ABBREVIATED PLAT AGENDA

April 22, 2026

STAFF REVIEW AND RECOMMENDATIONS
PUBLIC HEARING
APRIL 22, 2026

ABBREVIATED PLAT: GRAVEL GERTIE
LEGAL DESCRIPTION: SEC 29, T20N, R09E S.M., AK
PETITIONERS: TONY & CAROLYN SNEDIGAR
SURVEYOR/ENGINEER: GLOBAL POSITIONING SERVICES / RECON
ACRES: 14.65 +/- PARCELS: 2
REVIEWED BY: CHRIS CURLIN CASE #: 2026-027

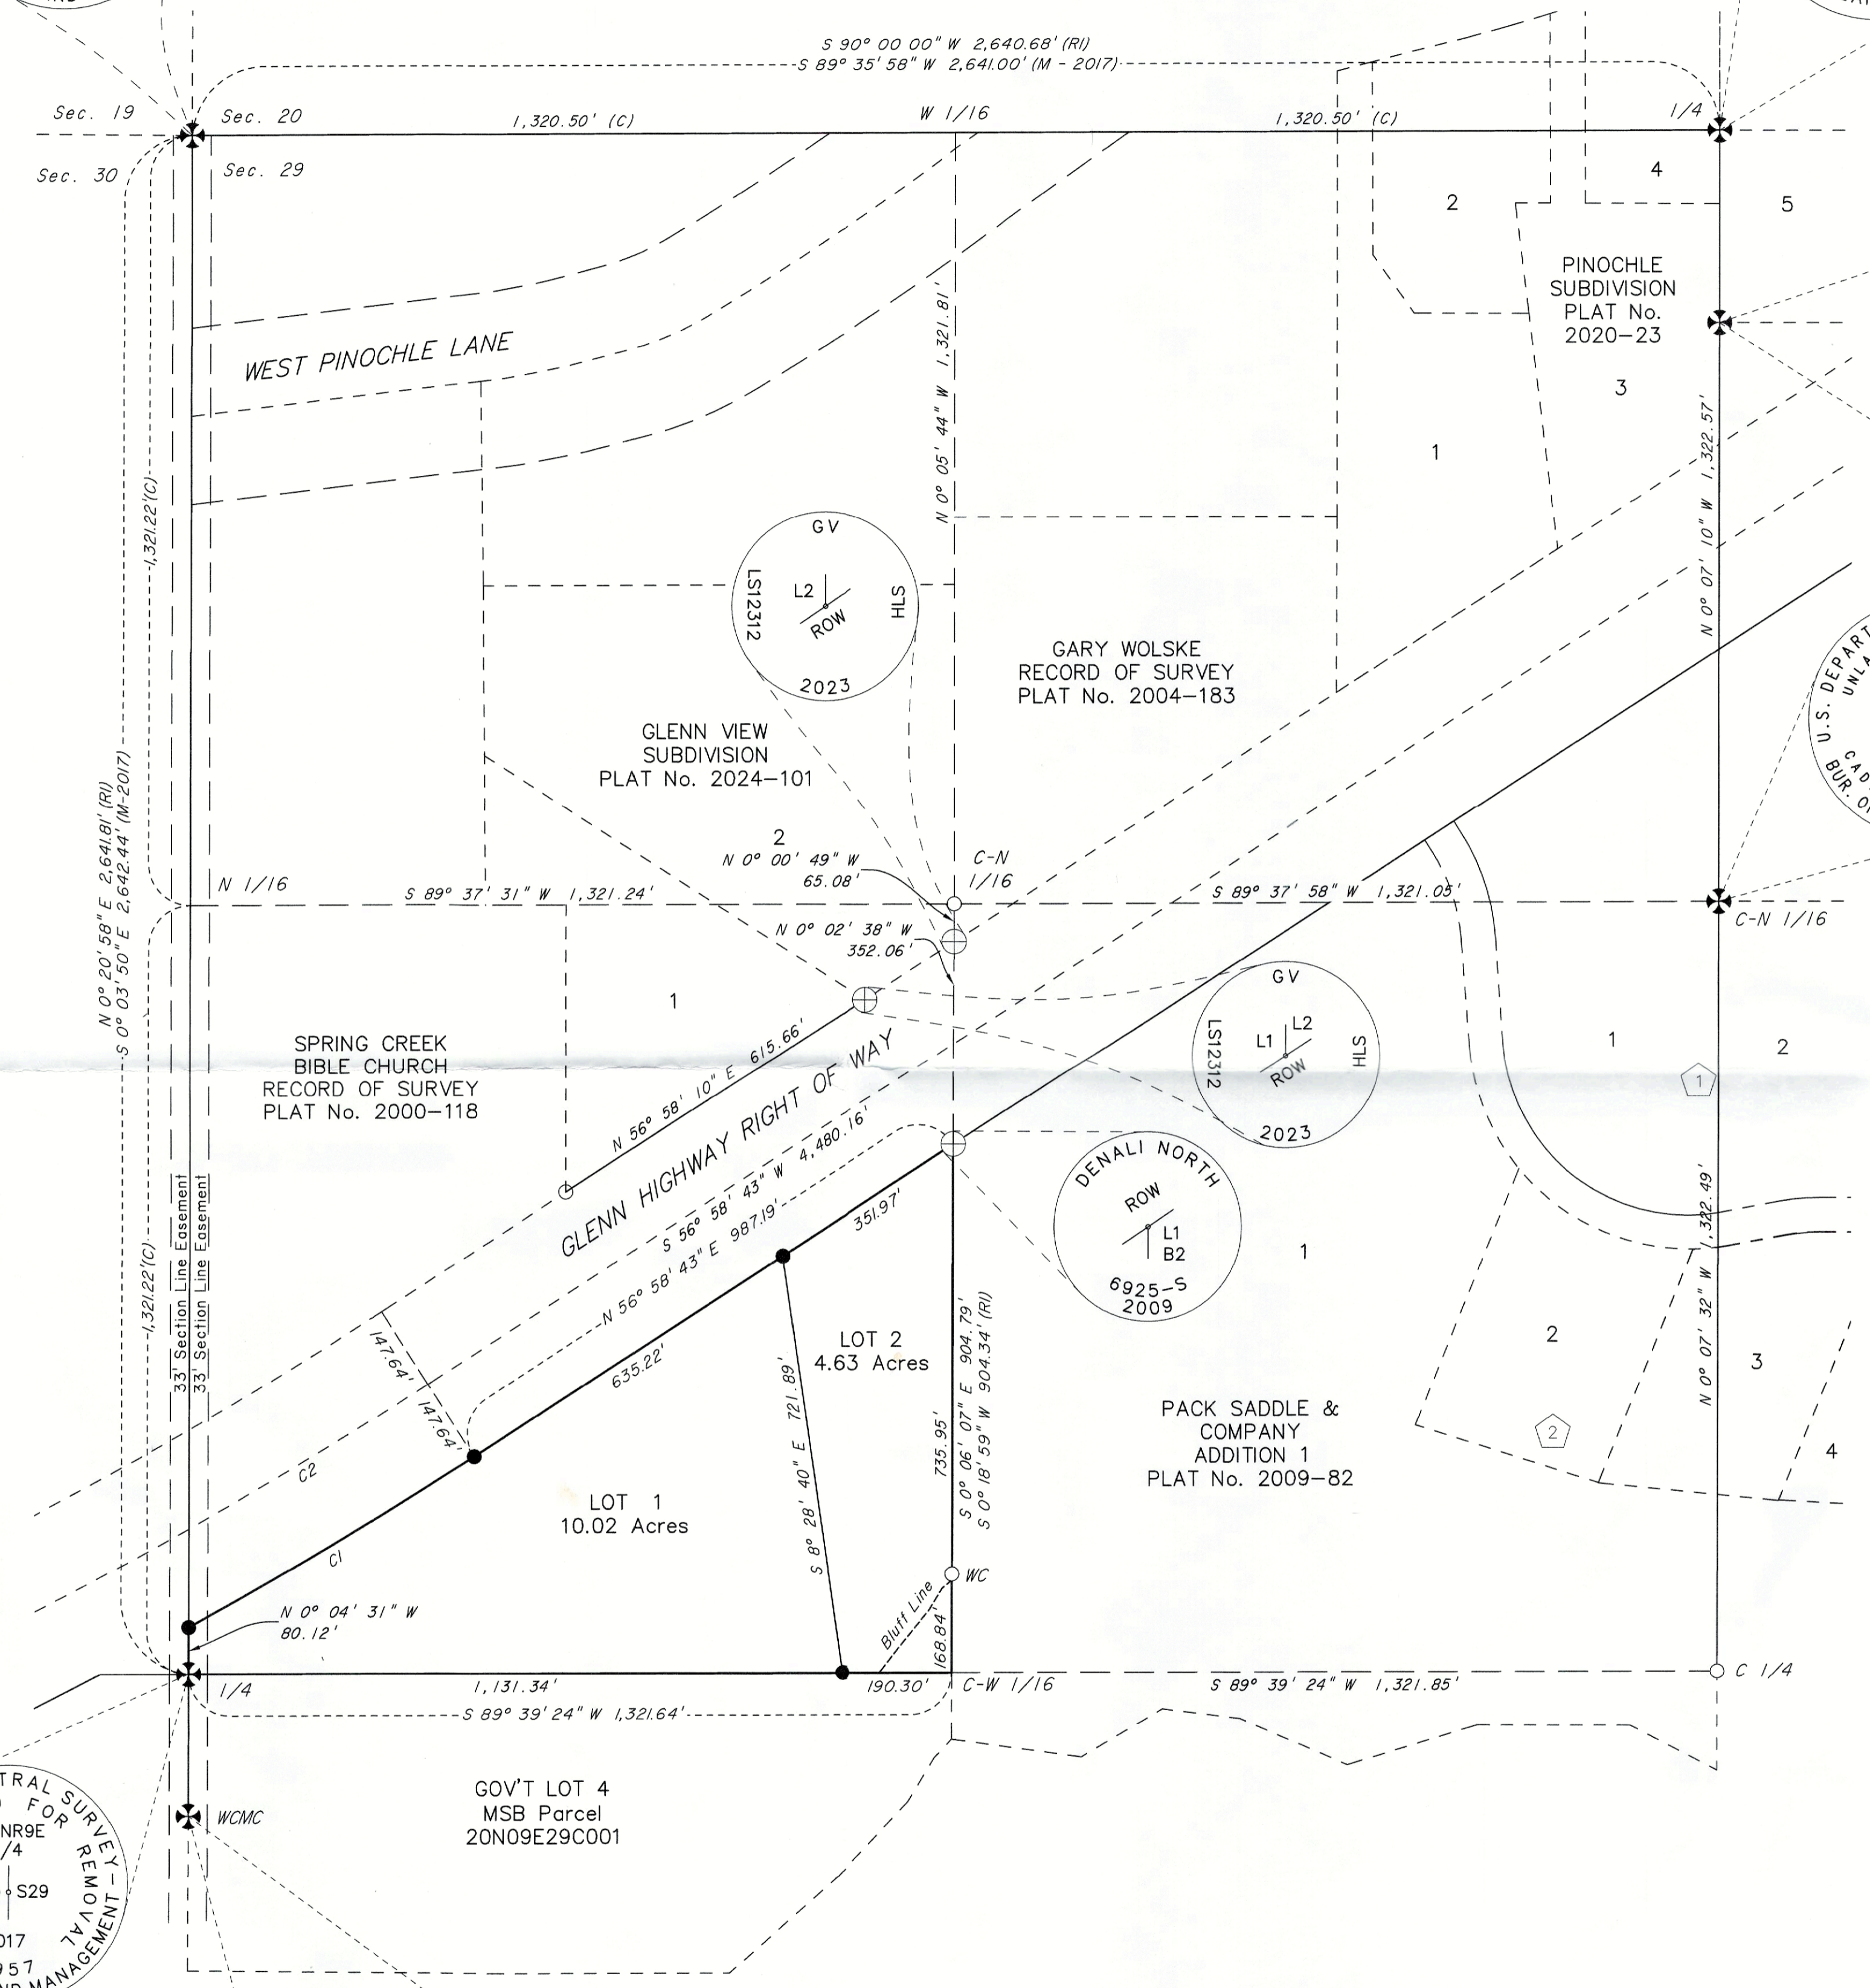
ADOT&PF (**Exhibit C**) No objection to lot division. Add plat note for both lots: One shared access to Glenn. Dedicate shared access easement.

Platting actions change lot legal descriptions and require access permits to be reapplied for. Reapply for shared access to the Glenn Highway for both lots. Driveway permits and Approach Road Review can be

MSB DPW Pre-Design and Engineering: **(Exhibit D)** PD&E recommends shared access to Glenn Highway. Coordinate with ADOT&PF.

- **Plat Case Number: 2026-027; Gravel Gertie; MG 05 Snedigar; Tax Parcel B6; (Glenn Highway MP 98.5)**
 - No objection to lot division.
 - Add plat note for both lots: One shared access to Glenn.
 - Dedicate shared access easement.
 - Platting actions change lot legal descriptions and require access permits to be reapplied for. Reapply for shared access to the Glenn Highway for both lots. Driveway permits and Approach Road Review can be applied for at DOT&PF's online ePermits website: <https://dot.alaska.gov/row/Login.po>. Please contact Gabe Kutcher in DOT&PF's ROW Property Management division at 907-269-0691 if you have any questions.

PD&E recommends shared access to Glenn Highway. Coordinate with ADOT&PF.

- ACCESS TO THE GLENN HIGHWAY IS LIMITED TO A SINGLE SHARED ACCESS FOR BOTH LOTS USING THE EXISTING DRIVEWAY.

ABBREVIATED PLAT: **LAZY MOOSE RUN L1A**

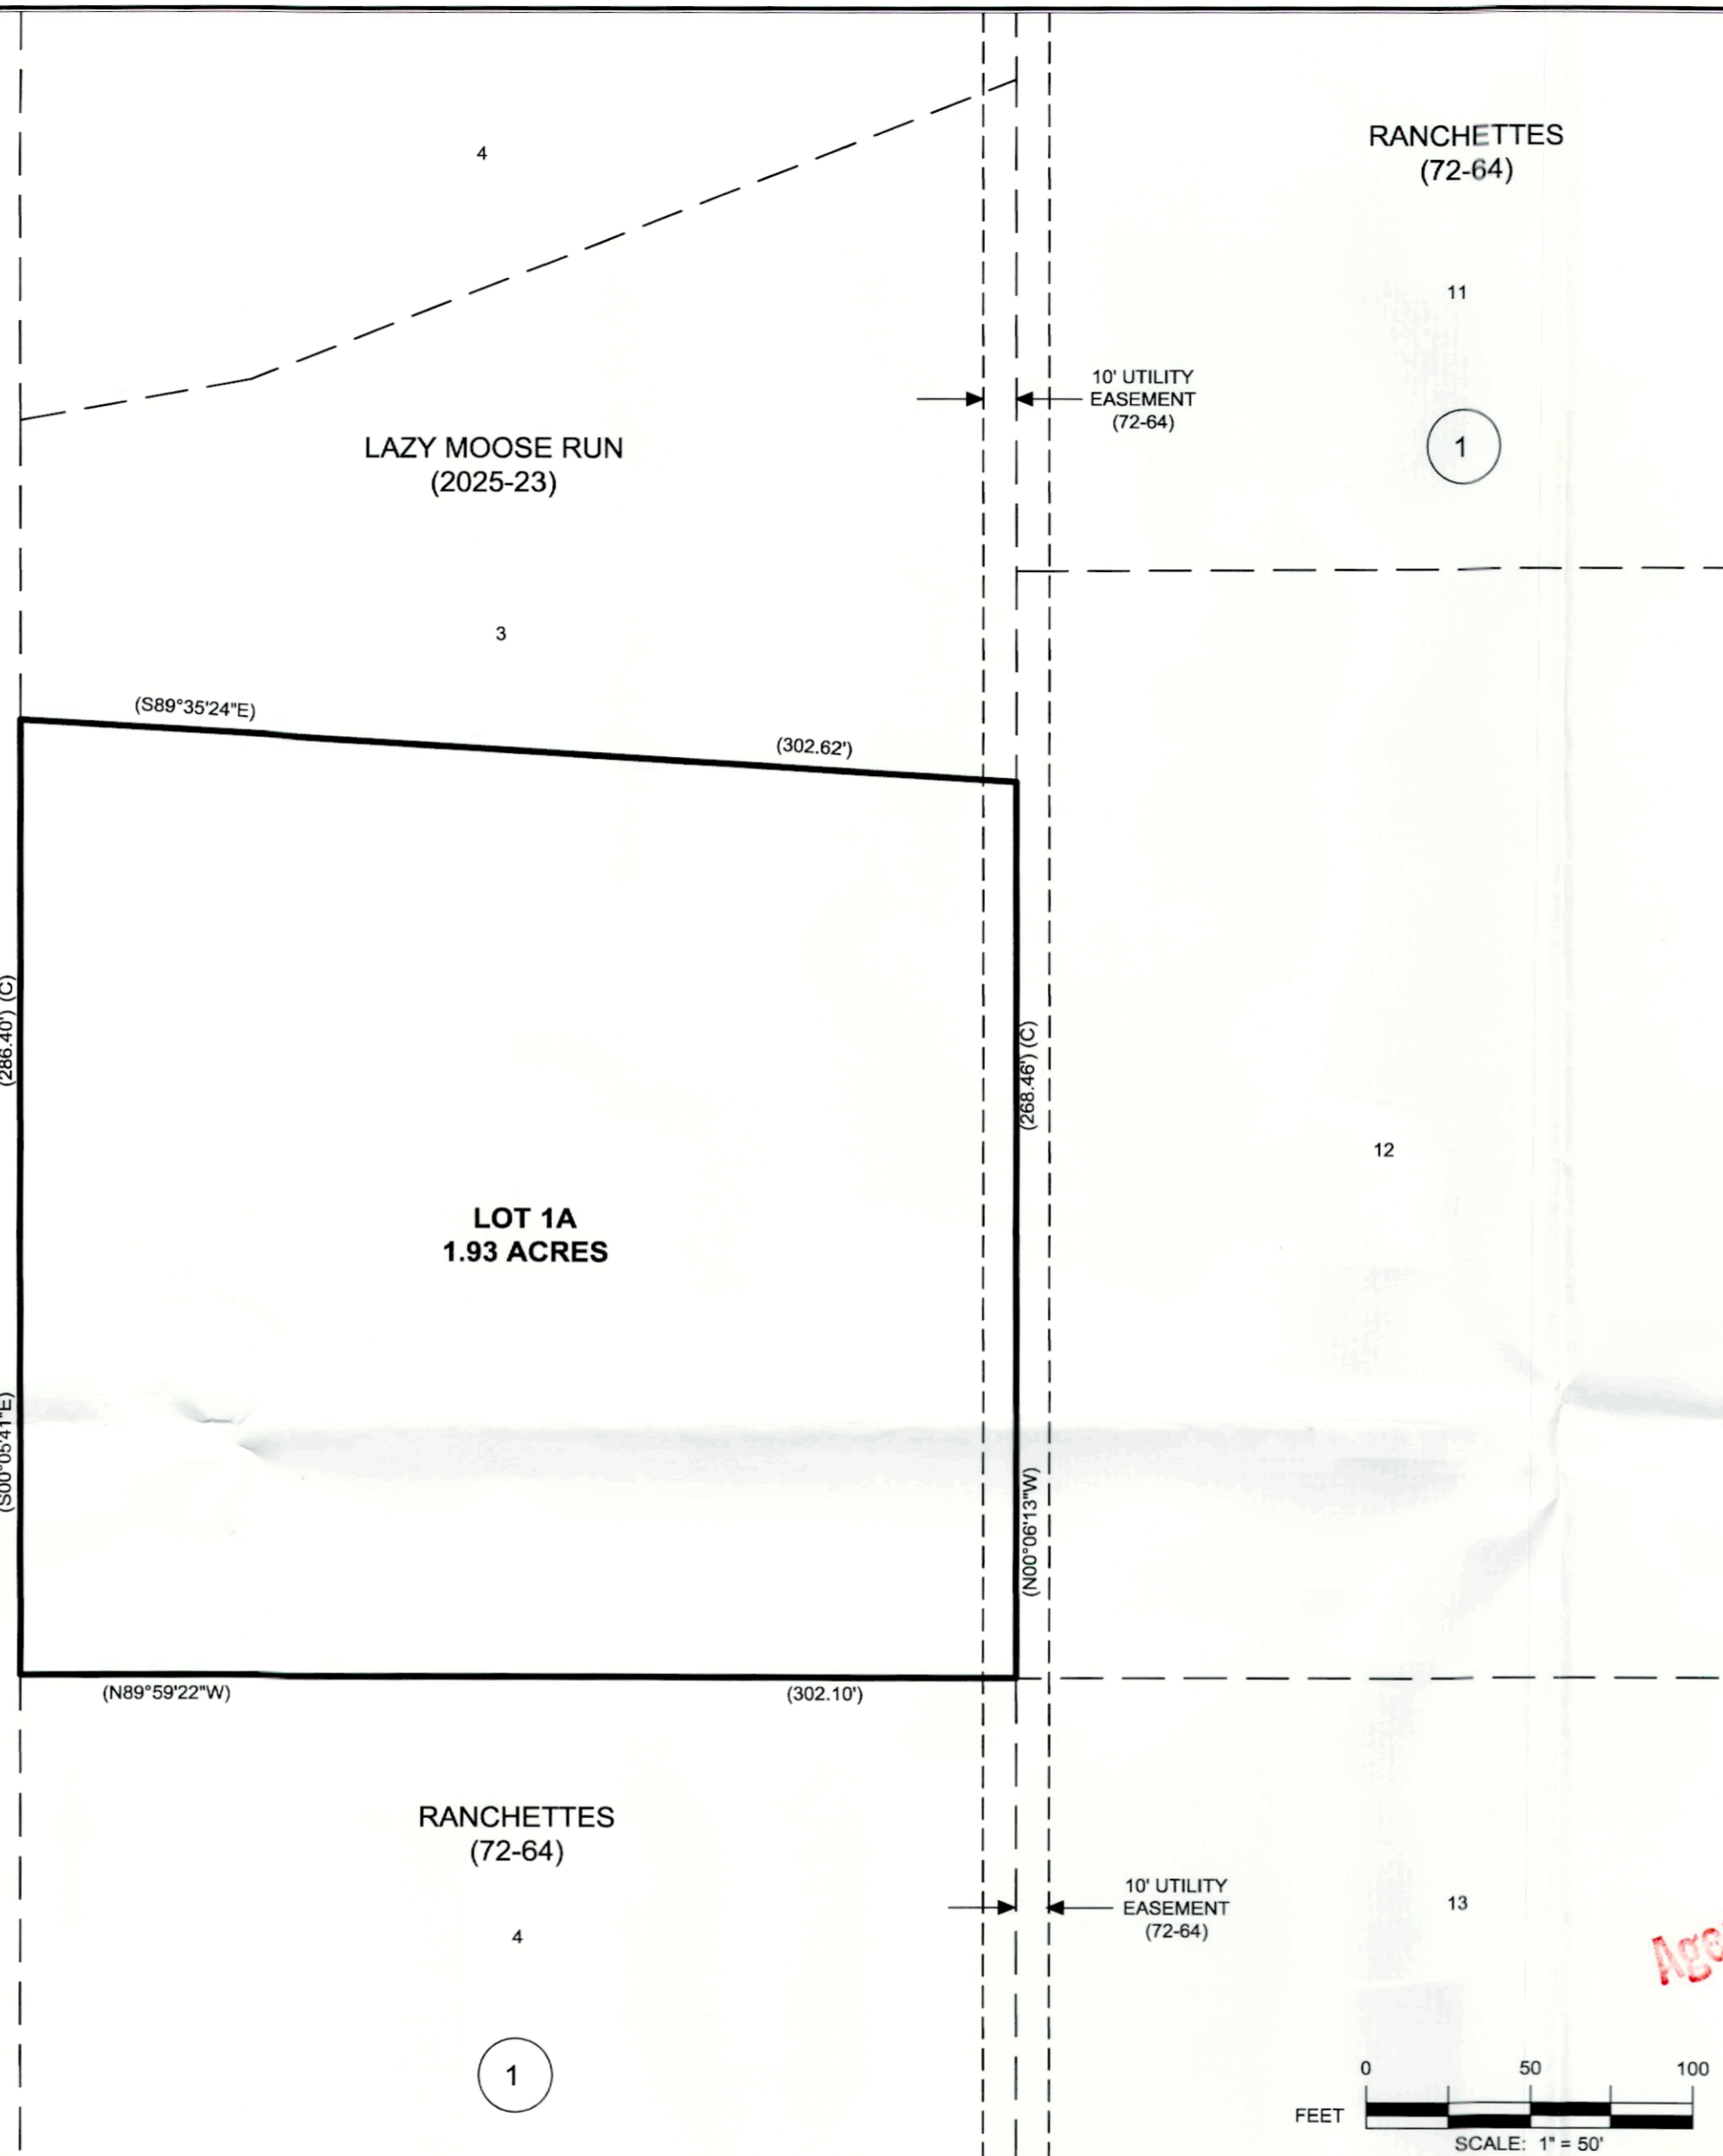
There were no objections or concerns received from Borough departments, outside agencies or the public at the time of this staff report. Per MSB Permit Center, if the driveway location is kept, it will require a driveway permit.

If they keep the driveway location, they'll need a permit. Otherwise, they can remove the driveway.
